South Texas Project Electric Generating Station P.O. Box 289 Wadsworth, Texas 77483

January 20, 2010
U7-C-STP-NRC-100026

South Texas Project
Units 3 and 4
Docket Nos. 52-001
Response to Request for Additional Information

FIGURE 6.2-39 ATMOSPHERIC CONTROL SYSTEM P&ID (Sheet 2 of 3)
 ABWR DCD/Tier 2 Rev.5

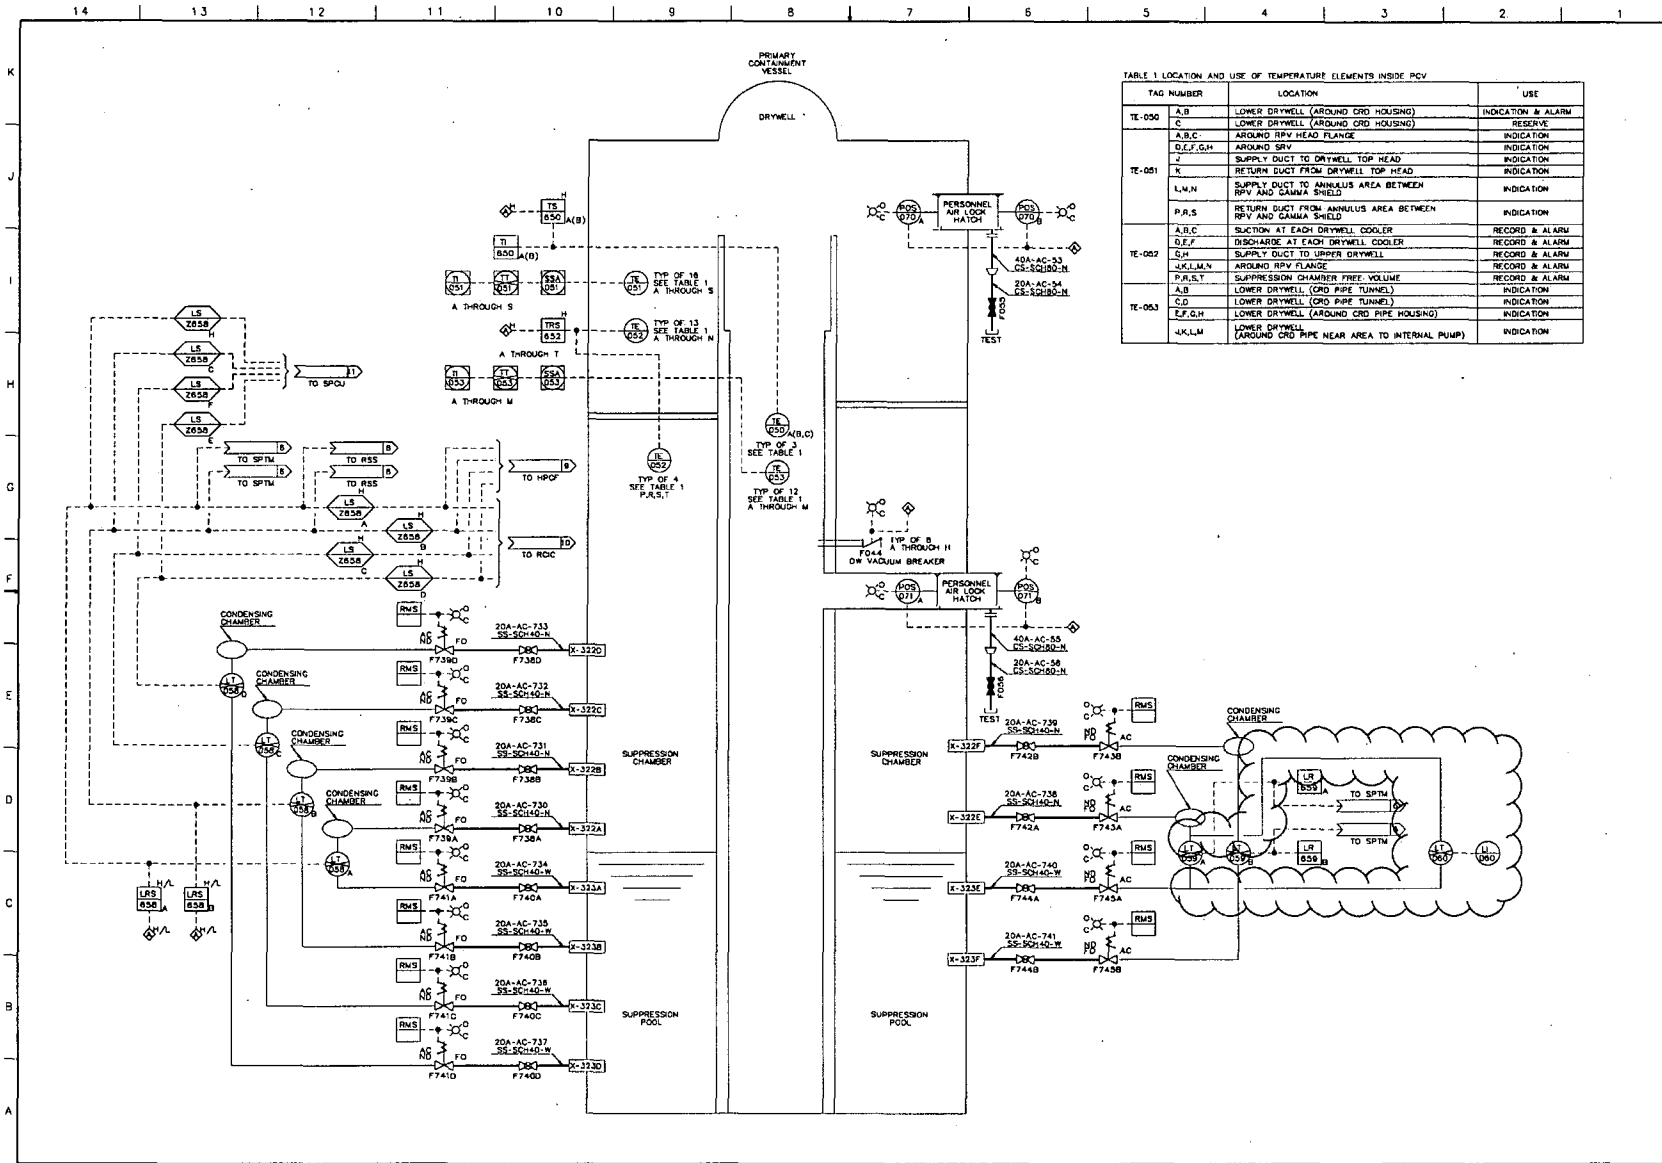
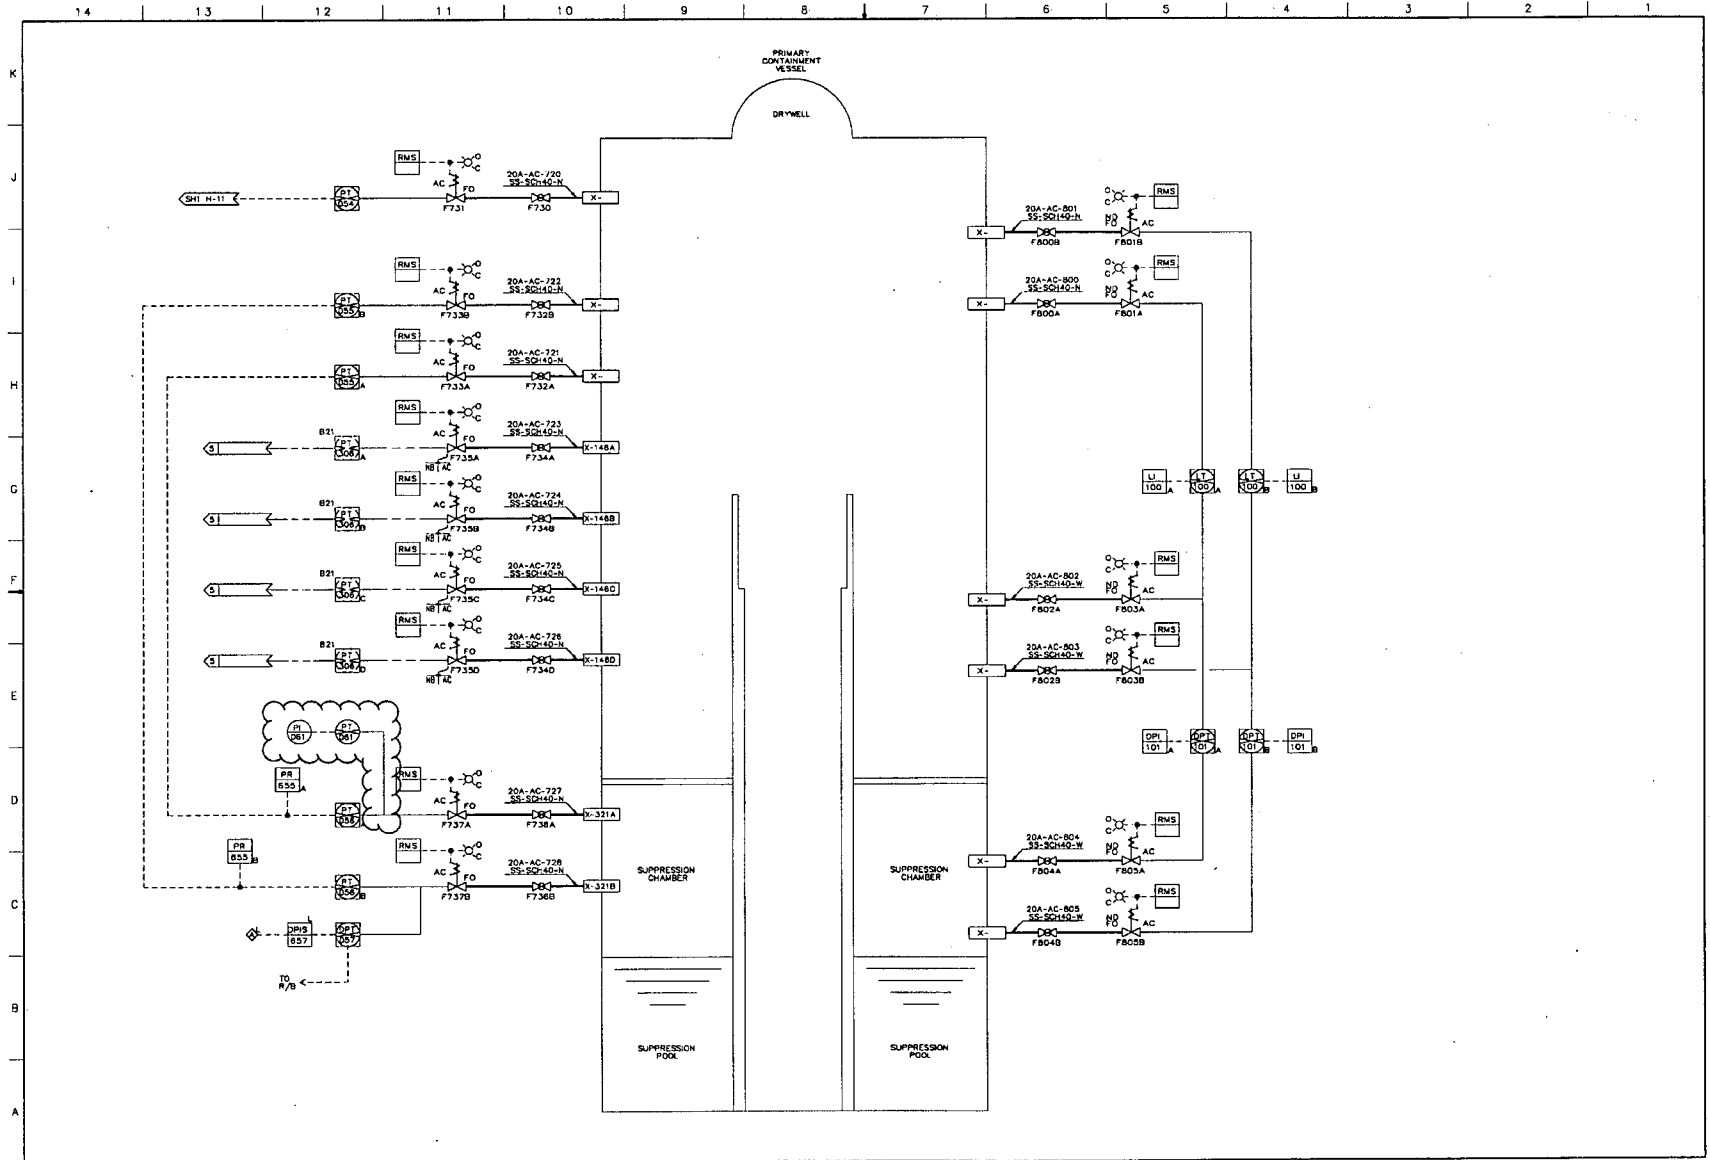
Subsection 7.7.1.1 of ABWR Design Certification Rule (DCR) application references Chapter 9.5.14 in the description of the reactor water level instrumentation provided for the Alternate Feedwater Injection System. Subsection 9.5.14.4 reads: "...*The instrument lines to be used for monitoring the alternate feedwater injection are branched from the existing line and are connected to new level and pressure transmitters*".

GDC 24 "Separation of protection and control systems" reads "*The protection system shall be separated from control systems to the extent that failure of any single control system component or channel, or failure or removal from service of any single protection system component or channel which is common to the control and protection systems leaves intact a system satisfying all reliability, redundancy, and independence requirements of the protection system. Interconnection of the protection and control systems shall be limited so as to assure that safety is not significantly impaired*".

The staff request the applicant to clarify how and where the connection is made from which the AFI system gets its instrumentation signals and to demonstrate that the instrumentation included in the new AFI system does not create any potential for inadvertent actuation or creates challenges to current safety systems.

The instrumentation connections for the AFI system are shown in the marked-up drawings for FSAR Figure 5.1-3, Sheet 5 provided in the original amendment submittal and in updated Figure 6.2-39, Sheets 2 and 3, attached to this RAI, which supersedes the Figure 6.2-39 markups provided in the original submittal. There are no automated control systems or functions for the AFI system, because it is a manually operated system. The instrumentation for the AFI system only includes indicators that are for operator information. In addition, the water level and pressure instrumentation in the AFI pump room uses separate transmitters and power supply from existing instrumentation. Consequently, the AFI system does not create any potential for inadvertent actuation or challenges to current safety systems.

FSAR Figure 6.2-39, Sheets 2 and 3 are changed as a result of this response.
